3GPP TSG-RAN3 Meeting #43
Prague, CZECH Republik, 16th-20th August 2004

Tdoc #R3-041244

CR-Form-v7	
CHANGE REQUEST	
# 25.413 CR 691 # rev 4 #	Current version: 5.9.0 #

Title:	# Data Volume Reporting Correction		
Source:	# RAN3		
Work item code:	# TEI5	Date:	# 16/08/2004
Category:	# F	Release:	# REL-5
	Use <u>one</u> of the following categories: F (correction) A (corresponds to a correction in an earlier release) B (addition of feature), C (functional modification of feature) D (editorial modification) Detailed explanations of the above categories can be found in 3GPP TR 21.900 .		Use <u>one</u> of the following releases: 2 (GSM Phase 2) R96 (Release 1996) R97 (Release 1997) R98 (Release 1998) R99 (Release 1999) Rel-4 (Release 4) Rel-5 (Release 5) Rel-6 (Release 6)

Figure 23: Data Volume Report procedure. Successful operation.

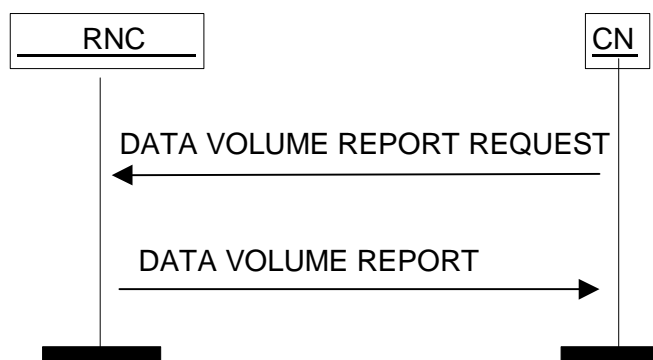
Reason for change:	# It is uncertain which data volume is to be reported at RAB release or lu release. Stage 2 TS32.200 has removed the use of data volume report procedure.
Summary of change:	# The Data Volume Report procedure is clarified to not be used any longer. Consequently the unsuccessfully transmitted data volume to be reported is clarified to be the volume since the establishment of the RAB. <u>Impact assessment towards the previous version of the specification (same release):</u> This CR has isolated impact towards the previous version of the specification (same release). This CR has an impact under functional point of view. The impact can be considered isolated because it only affects the RAB Assignment, lu Release procedure and Data Volume Report. The CR may affect implementations based on previous version of this specification and not behaving according to TS 32.200.
Consequences if not approved:	# Incorrect data volume reported in lu Release Complete and RAB Assignment Response.

NOTE: [In line with TS32.200, this procedure is not used and the RNC should ignore a DATA VOLUME REPORT REQUEST message if received.](#)

Figure 23: Data Volume Report procedure. Successful operation.

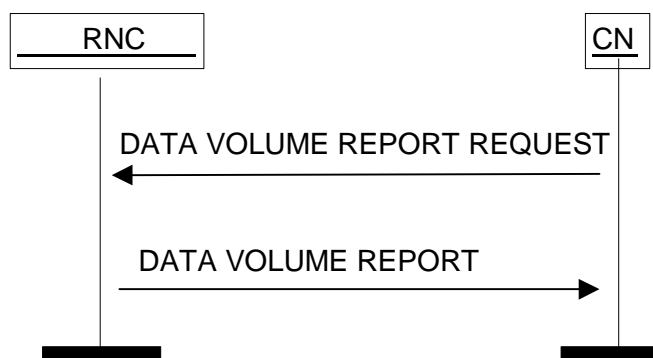
Reason for change:	# It is uncertain which data volume is to be reported at RAB release or lu release. Stage 2 TS32.200 has removed the use of data volume report procedure.
Summary of change:	# The Data Volume Report procedure is clarified to not be used any longer. Consequently the unsuccessfully transmitted data volume to be reported is clarified to be the volume since the establishment of the RAB. <u>Impact assessment towards the previous version of the specification (same release):</u> This CR has isolated impact towards the previous version of the specification (same release). This CR has an impact under functional point of view. The impact can be considered isolated because it only affects the RAB Assignment, lu Release and Data Volume Report procedures. The CR may affect implementations based on previous version of this specification and not behaving according to TS32.200.

NOTE: In line with TS32.200, this procedure is not used and the RNC should ignore a DATA VOLUME REPORT REQUEST message if received.
